CITY OF LAS VEGAS INTER-OFFICE MEMORANDUM		DATE: September 4, 2019
TO: Land Development Services Department of Building & Safety		FROM: Albert Sung, P.E. Flood Control Project Engineer Department of Public Works
SUBJECT: Drainage Study for: Summerlin West V22 – Kestrel Creek Avenue (Street I) (from Desert Foothills Drive to Kettle Ridge Drive <Street J>)		COPIES TO: Atkins
Cross Streets:	Desert Foothill Drive & Kestrel Creek Ave.	Howard Hughes Company, LLC
File Number:	F:\Depot\DSMemos\DS5171A.doc	Bart Anderson, P.E., DevCo
Parcel Number:	137-14-401-006 & 137-23-101-002	
Zoning Action:	N/A	
FEMA Flood Zone	YES NO X	
Proposed Storm Drain	YES X NO

The Drainage Study for the subject project has been reviewed and:

SUMMERLIN VILLAGE 22
KESTREL CREEK AVENUE (STREET I)
DESERT FOOTHILLS DRIVE TO KESTREL CREEK DRIVE (STREET J)

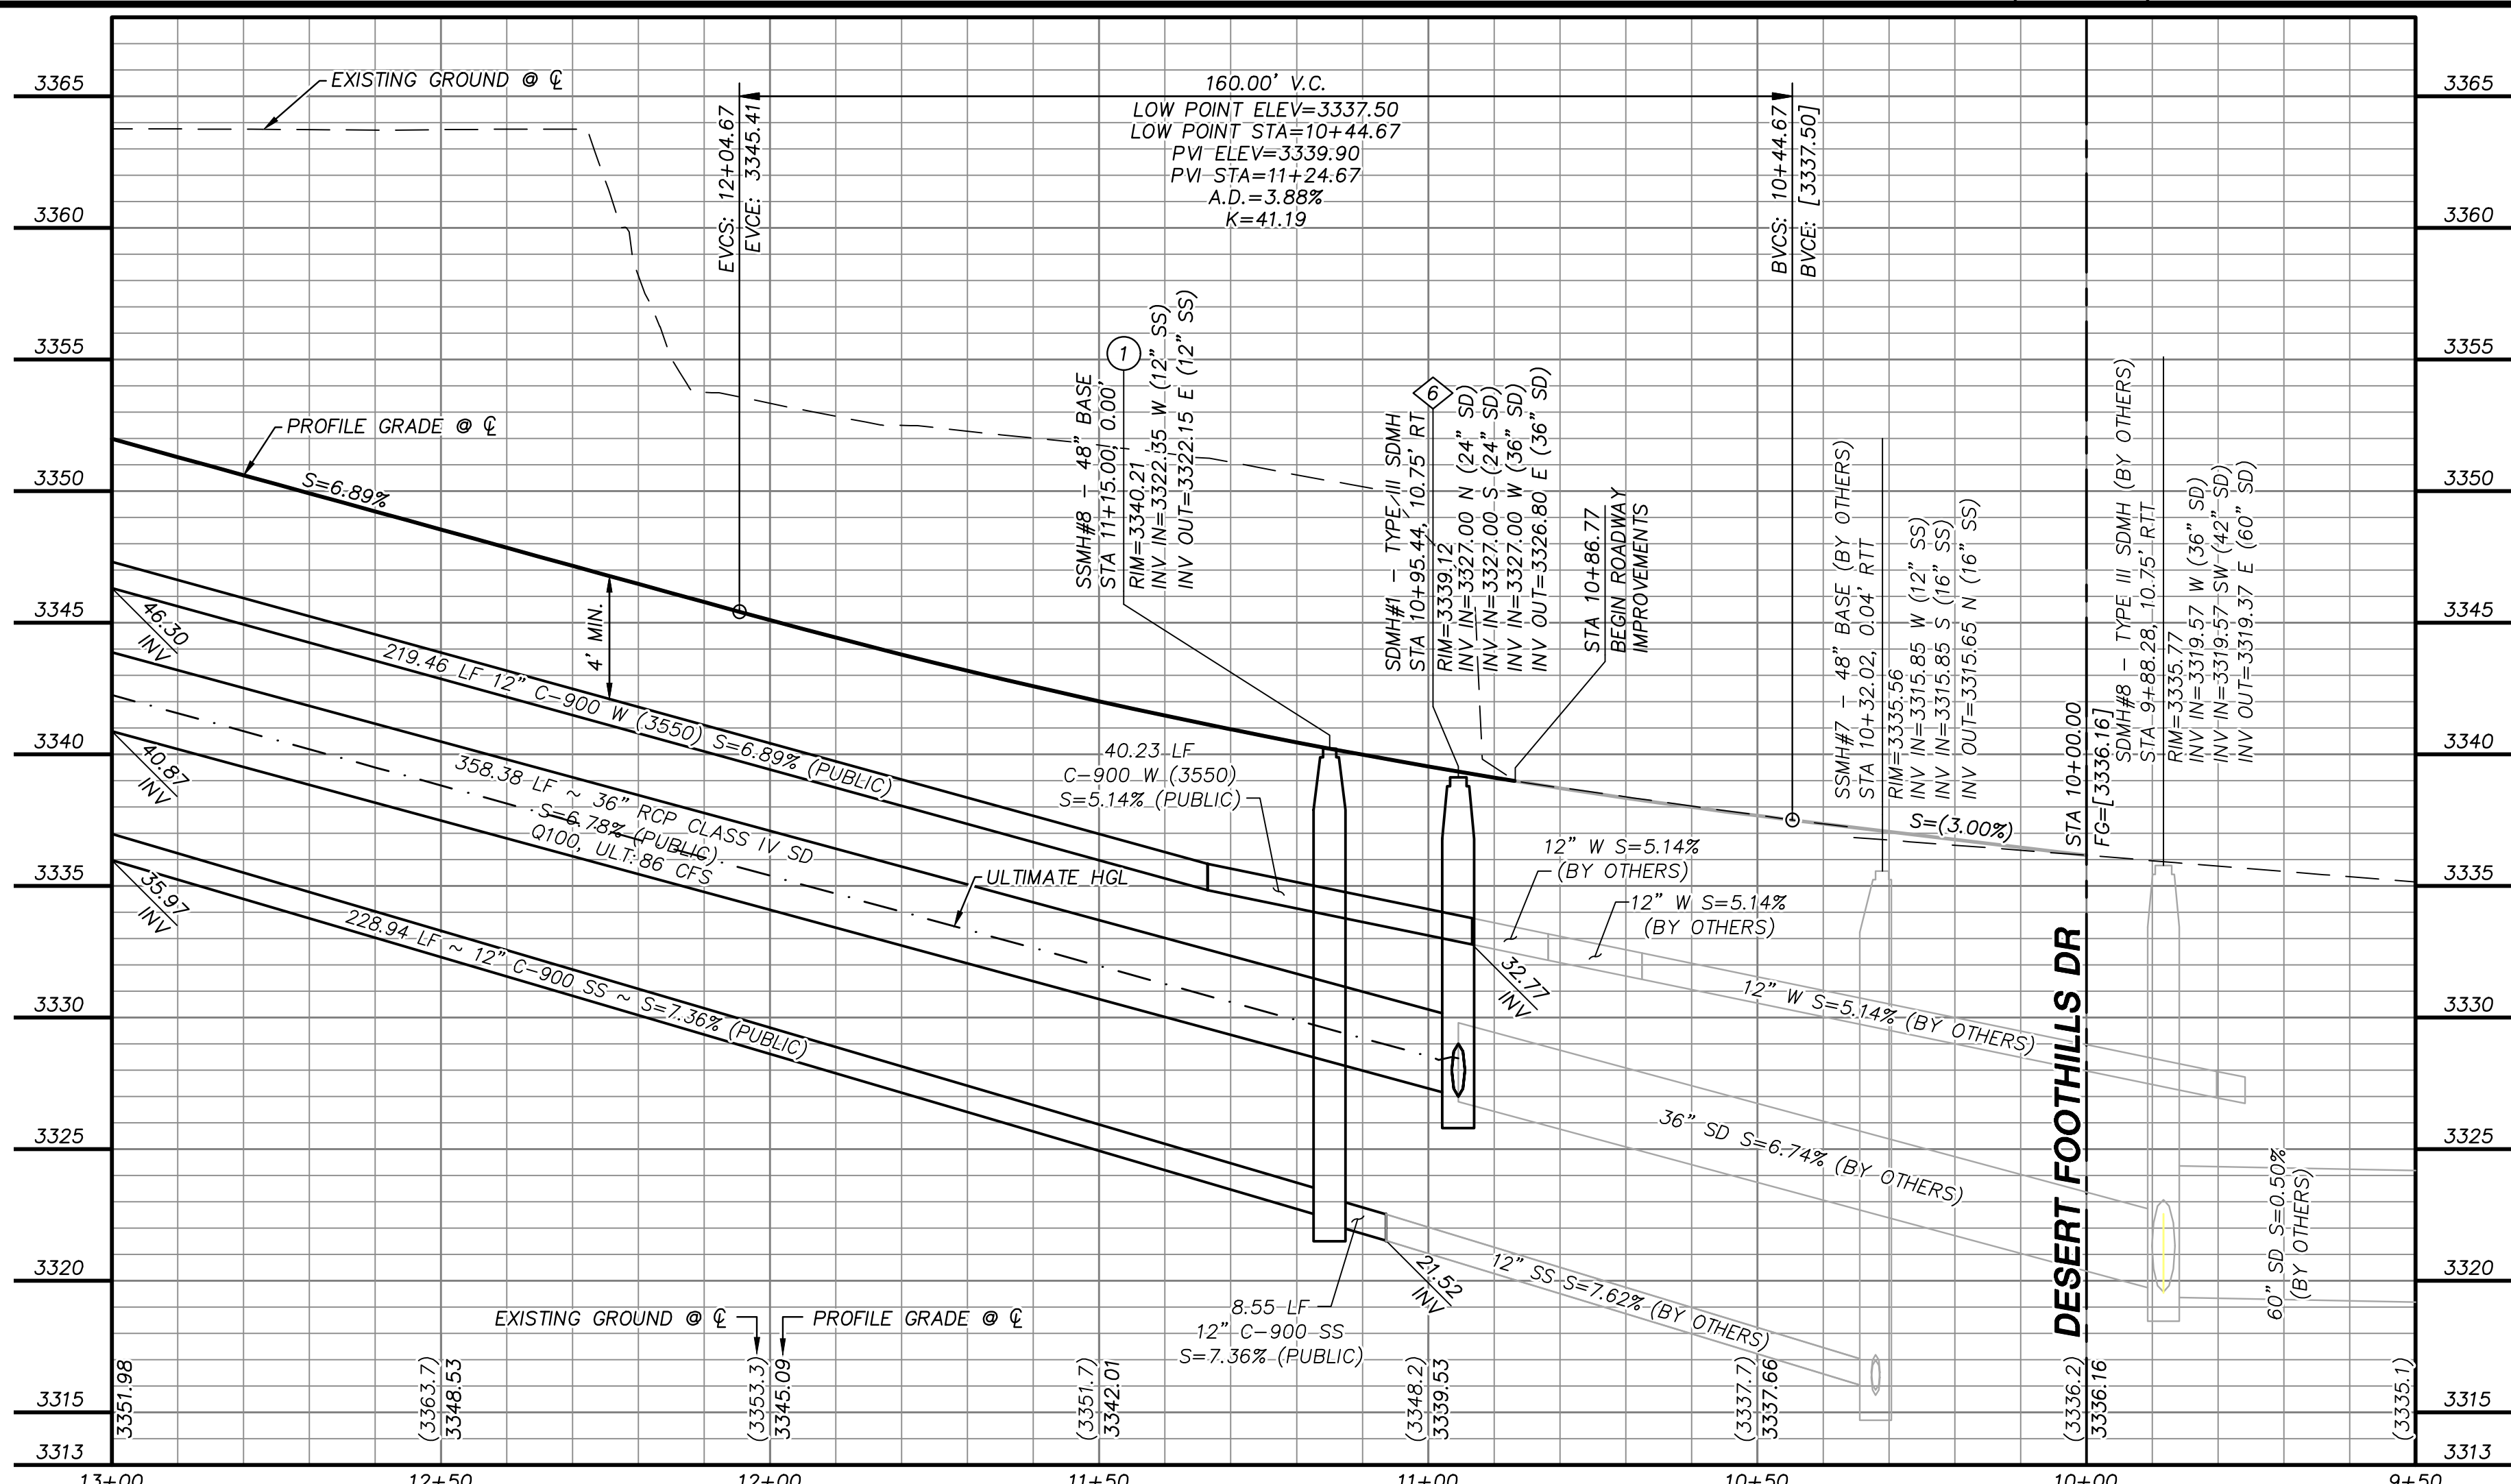
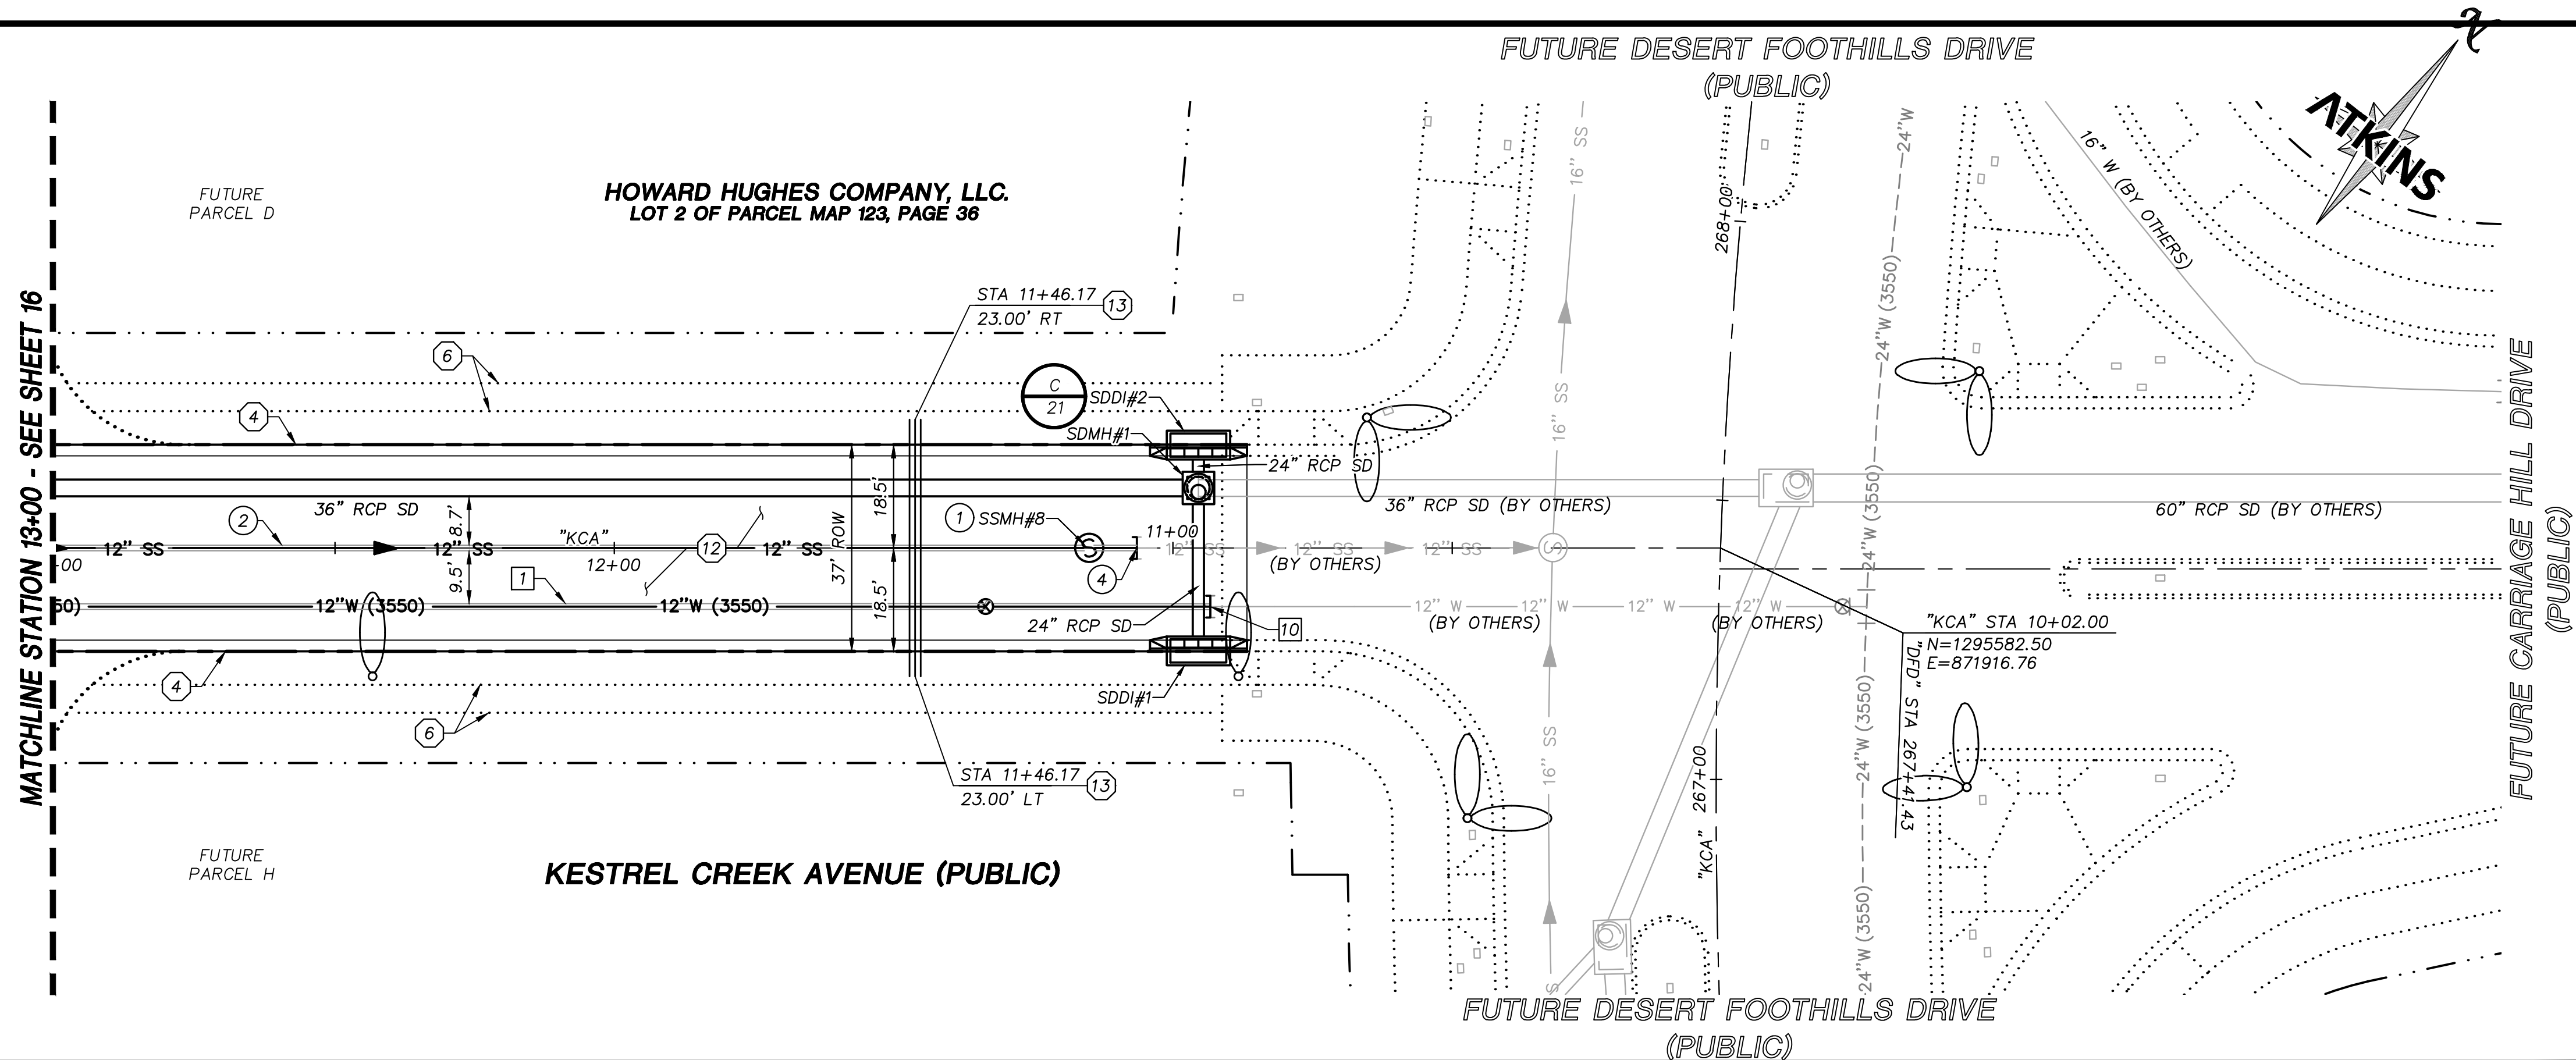
5. **Sheet 17/27 and Sheet 18/27:** It is assumed that the sequence of construction is that the storm drain system at the intersection of *Desert Foothills Drive* and *Kestrel Creek Avenue* to be installed prior to the subject improvements. Therefore the storm drains downstream of SDMH #1 should be existing in regard to the subject project. Revise the line type of the storm drains "BY OTHERS" to broken line to reflect "Existing" status in the next submittal.

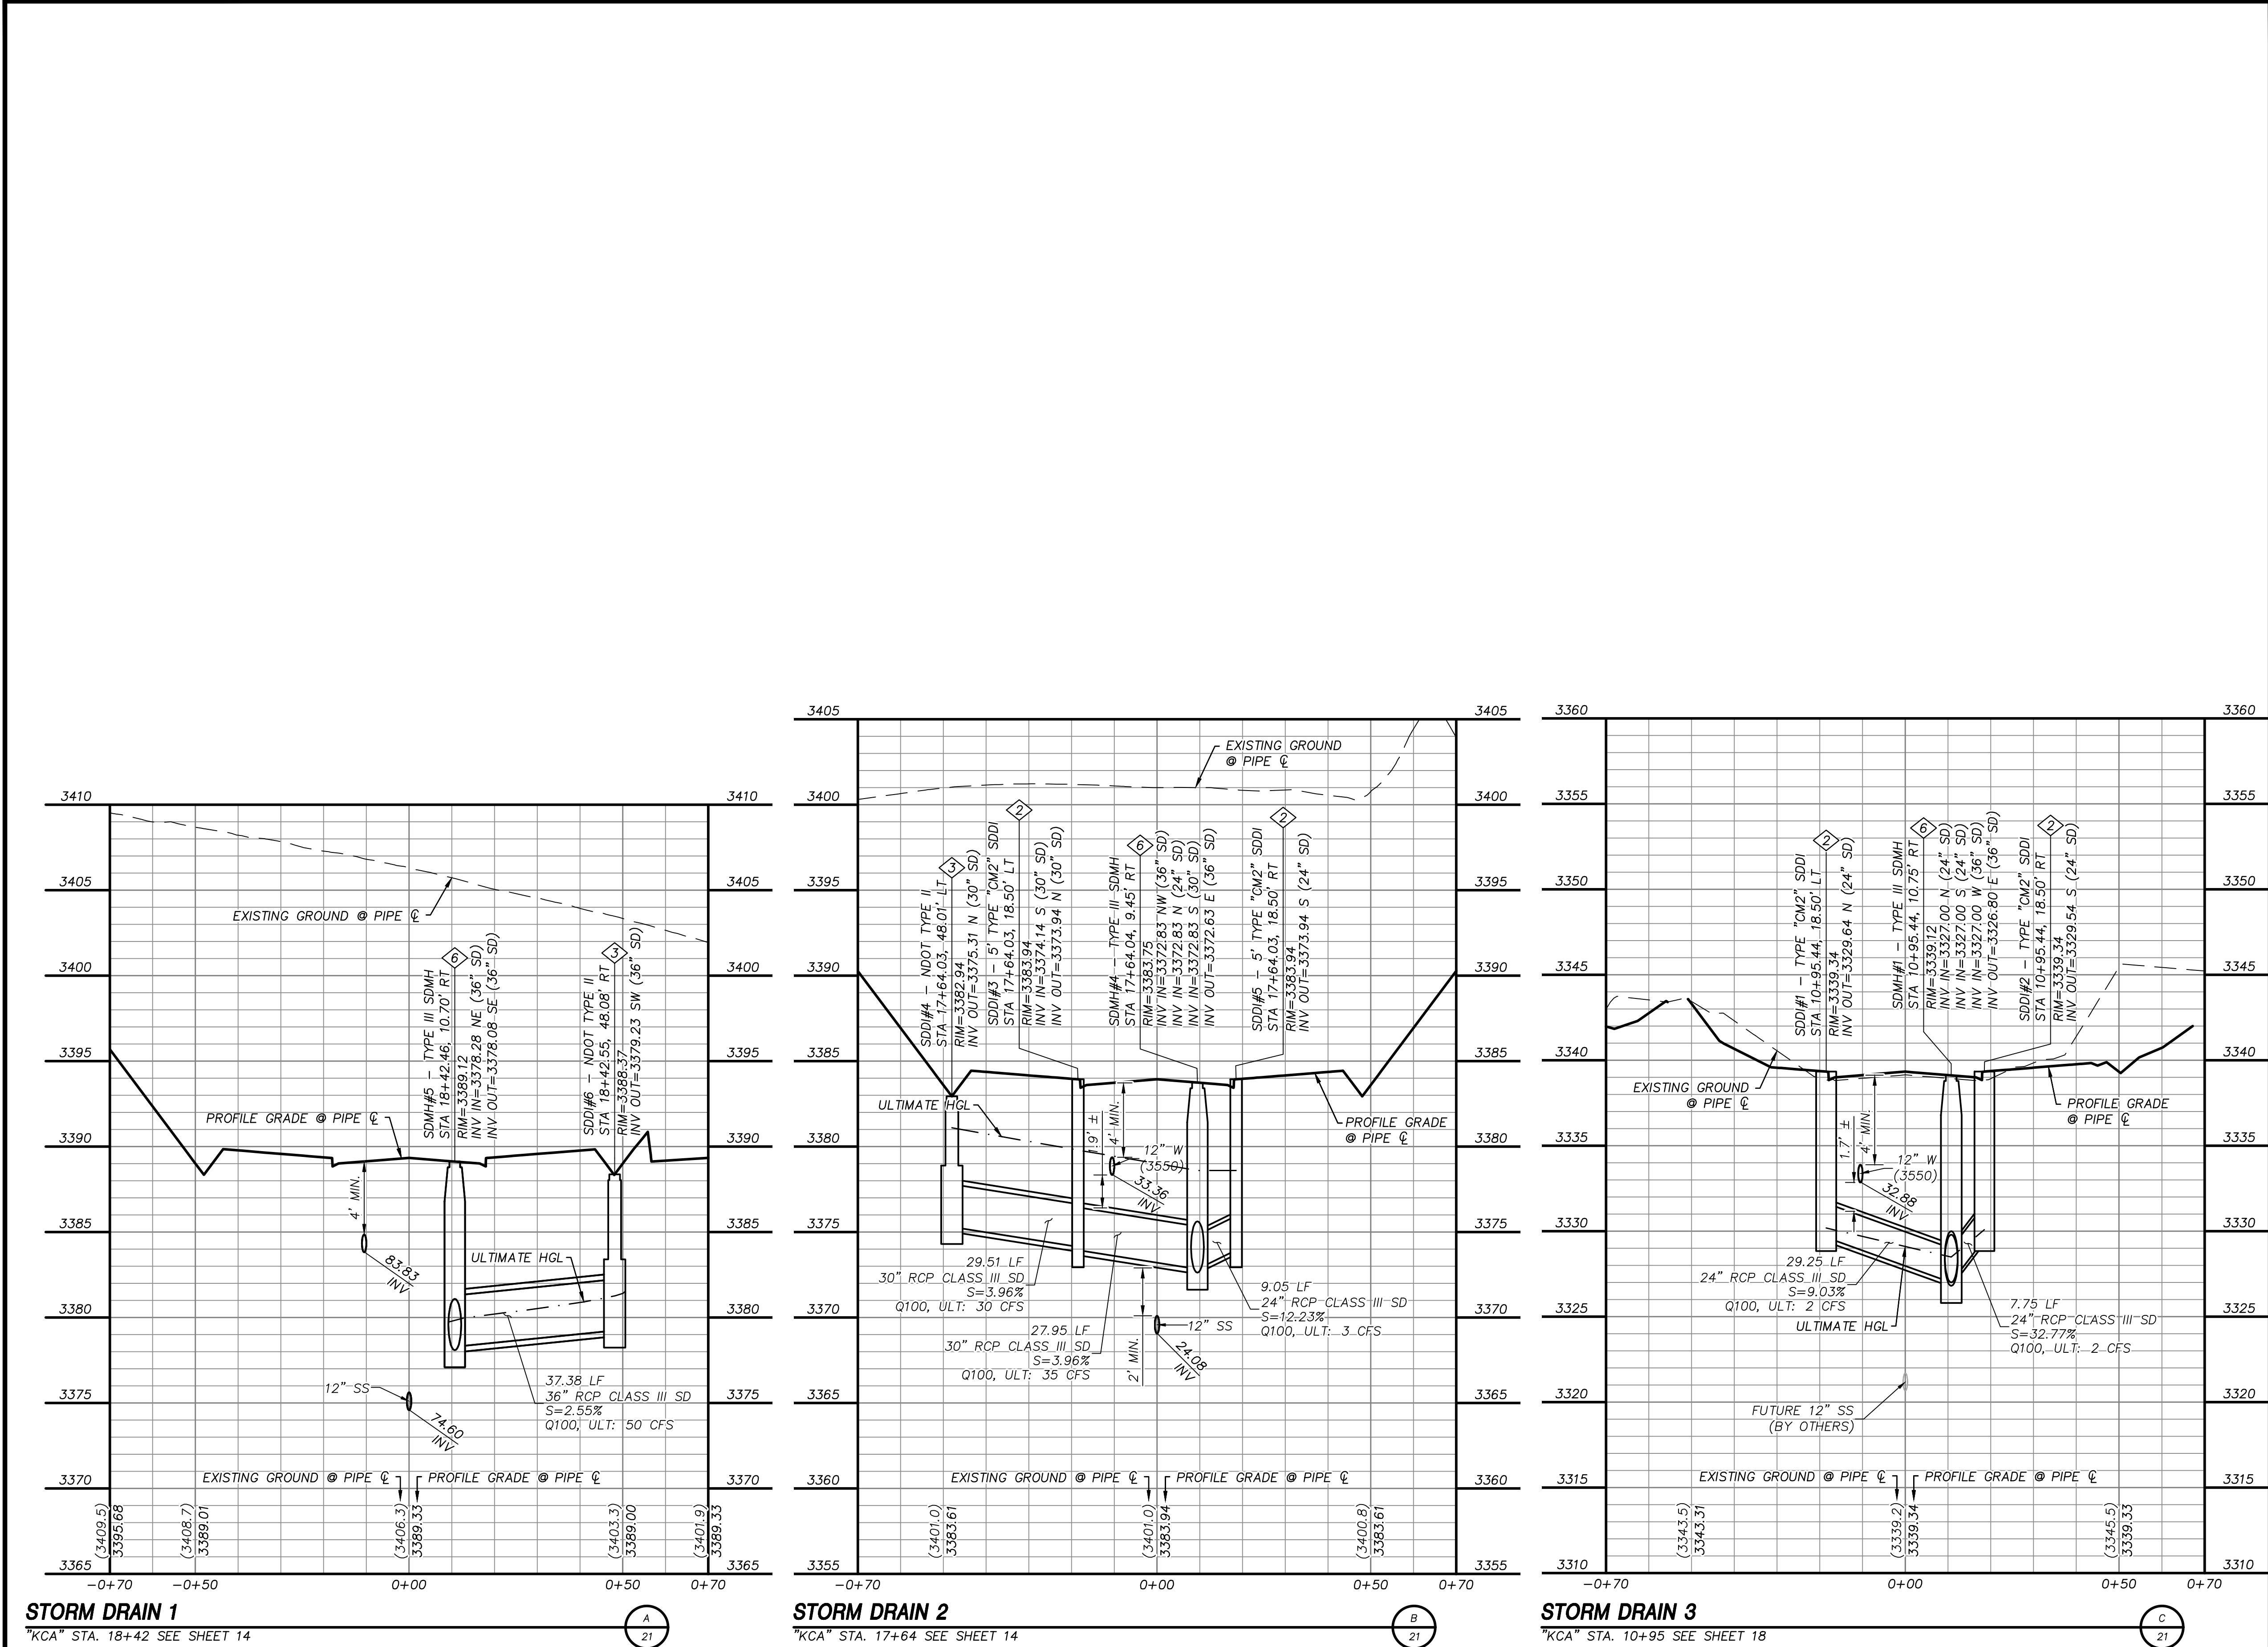
3. **Sheet 9/27:** A comment was issued for the *Kettle Ridge Drive Improvements Drainage Study* to relocate the regional storm drain towards the street center as much as possible. However, the subject improvement plan still shows that the regional facility under the curb & gutter of *Kettle Ridge*. Review and revise accordingly.
